From: The Columbia County Building & Zoning Department

Plan Review

Reference to a building permit application Number: 0704-76

Donald Davis, Owner Derrel Murkerson Property ID#25-7s-16-04321-024

MAIN FLOORPLAN SCALE: 3/16"=1'-0"

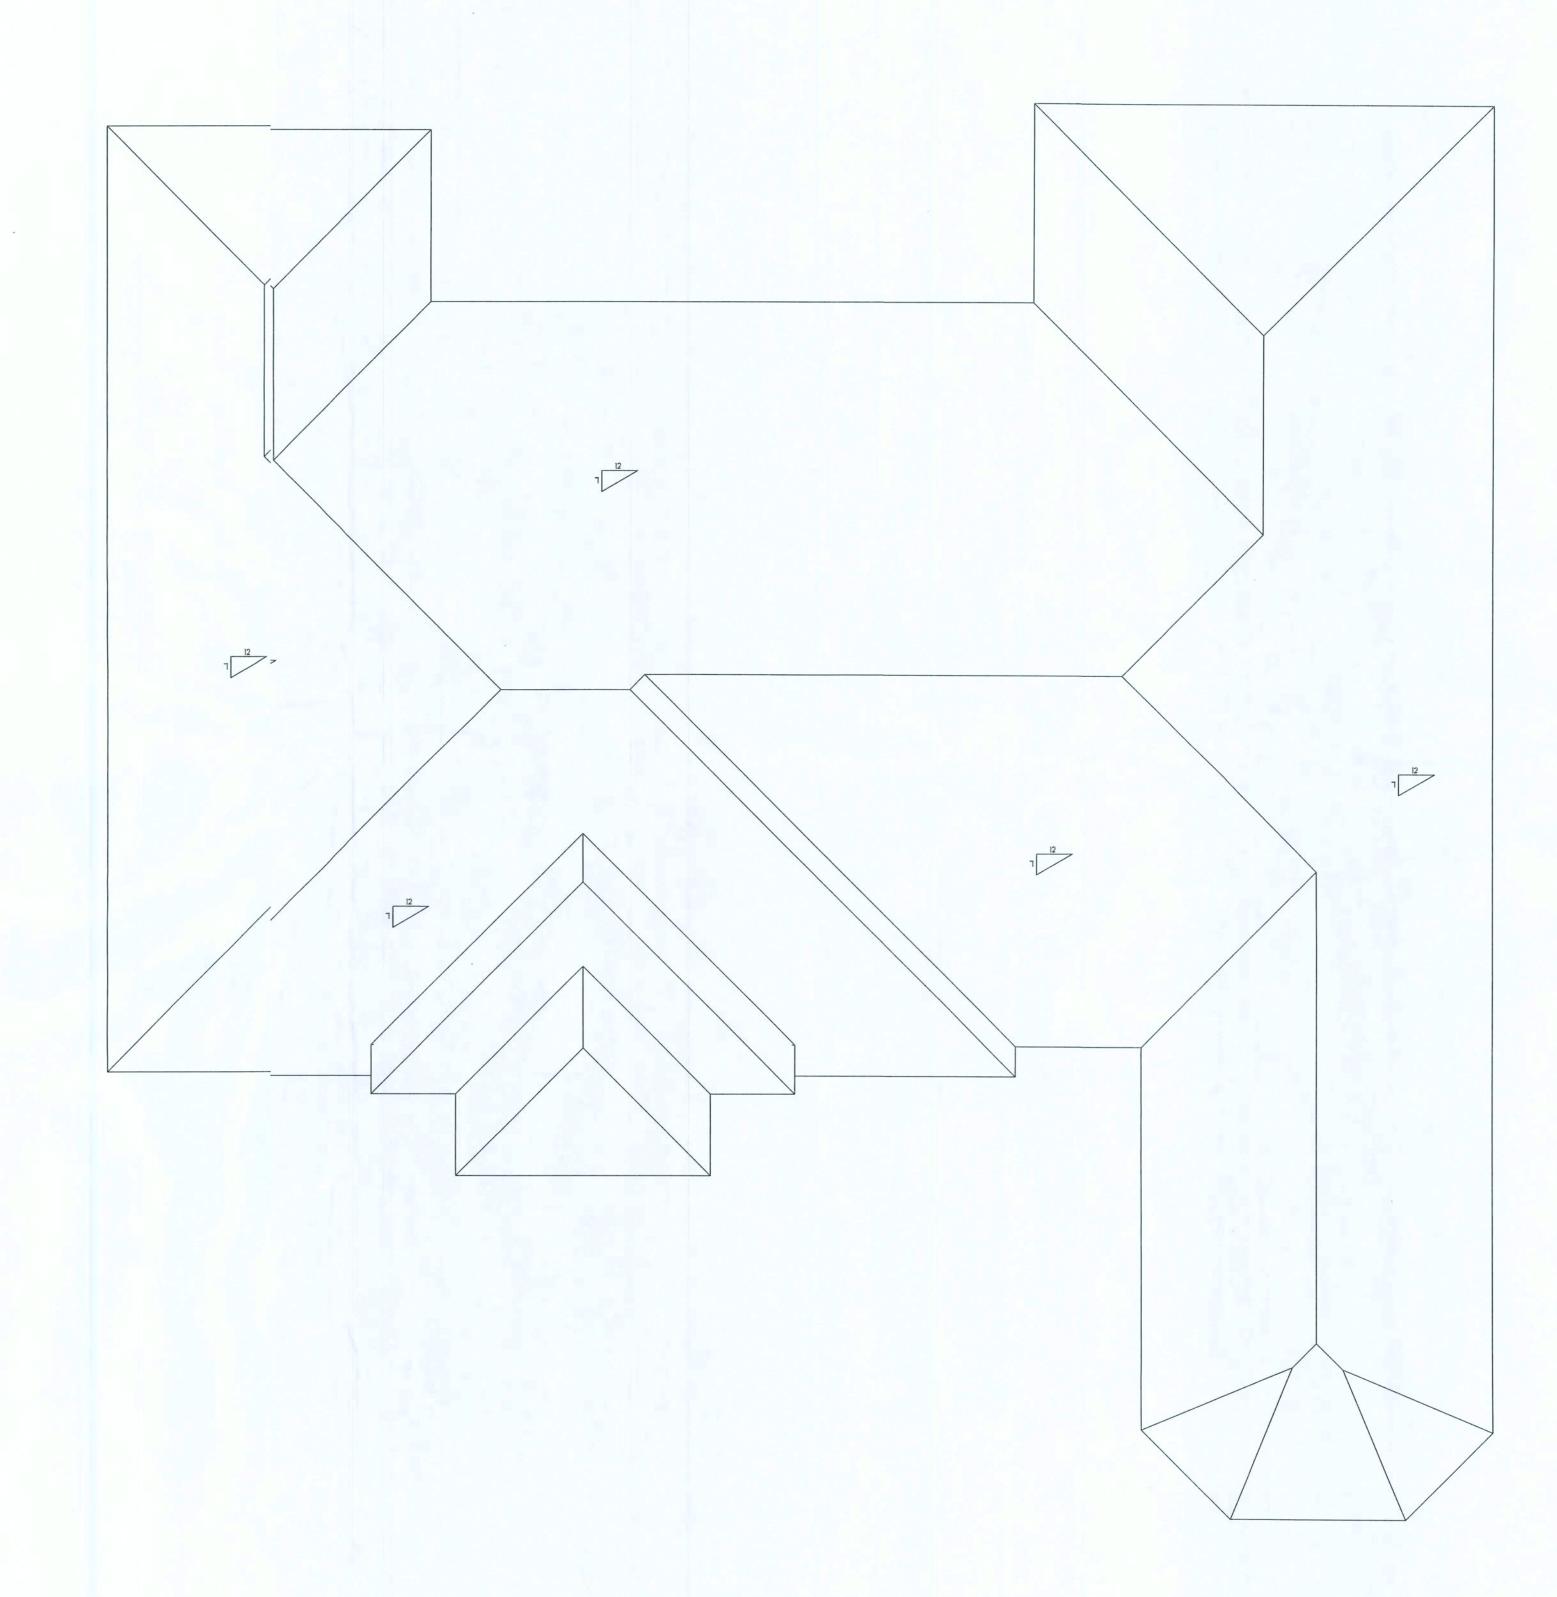
- 3. The attic access opening (pull down ladder type attic egress dor) in the garage ceiling shall have the same protection requirements of RC-2004 C: R309.2 Separation required. The garage shall be separatefrom the residence and its attic area by not less than ½-inch (12.7 mm) ypsum board applied to the garage side. Garages beneath habitable roms shall be separated from all habitable rooms above by not less than ½-inch (15.9 mm) Type X gypsum board or equivalent. Where the sepration is a floor-ceiling assembly, the structure supporting the separation hall also be protected by not less than ½-inch (12.7 mm) gypsum boardr equivalent. Other openings between the garage and residence hall be equipped with solid wood doors not less than 13/8 inches (35 mm) in thickness, solid or honeycomb core steel doors not less than 1/8 inches (35 mm) thick, or 20-minute fire-rated doors.

ELECTRICAL PLAN

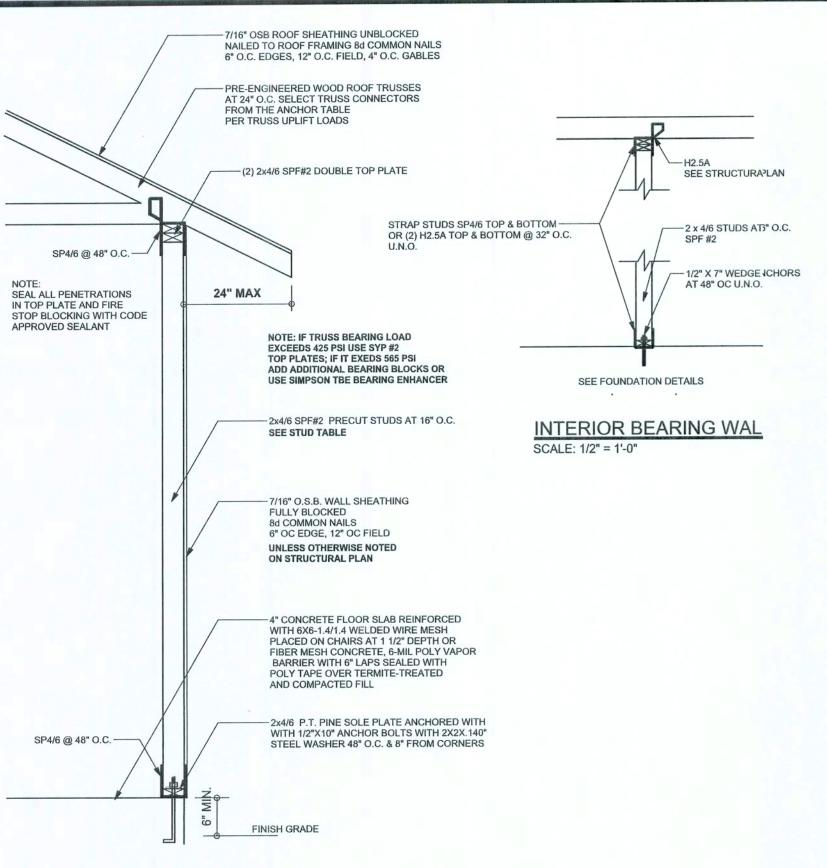
1. Please show on the electrical plans the location of the air handling unit and the water heater.

- 2. On the electrical plans identify the electrical service overcurrer protection device for the main electrical service. This device shall be institled on the exterior of structures to serve as a disconnecting means for that tility company electrical service. Conductors used from the exterior disconnecting means to a panel or sub panel shall have four-we conductors, of which one conductor shall be used as an equipient ground.
